# **PUBLIC SCHOOL DEVELOPMENT STANDARD ADVISORY COMMITTEE**

## **KIMBALL ELEMENTARY SCHOOL DESIGN DEPARTURE RECOMMENDATIONS**

**Project #3035786-SD**

**July 30, 2020**

### Exhibit 6 Proposed Bicycle Long-Term Bike Storage

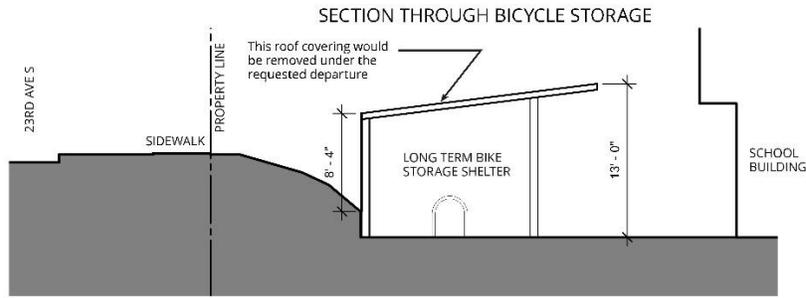
Several comments shared the belief that to encourage students and staff to ride more requires the ability to park their bikes in a place that protects them from the weather and to not cover the long-term bike parking effectively means it is no longer long-term bike parking. The safety concern of people climbing onto the structure should not outweigh the need for secure bike parking and can be dealt with through design and placement of the structure.

**Recommendation 5 – That the departure to not provide secure bicycle parking be DENIED as requested by the Seattle Public Schools.**

**Exhibit 9 Proposed Message Board**

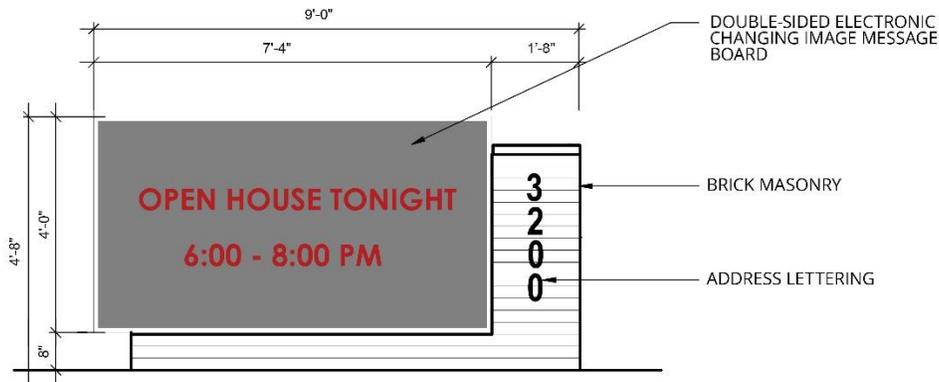
One comment was received saying the sign is not a top priority and another comment noting that it will help drive community engagement and awareness of school events. The sign does not appear to be of large concern to the community. The following conditions are recommended to mitigate the perceived impacts on the surrounding neighborhood.

**Recommendation 6 – That the departure to allow an electronic message board be GRANTED as requested by the Seattle Public Schools without modification and with the following conditions:**
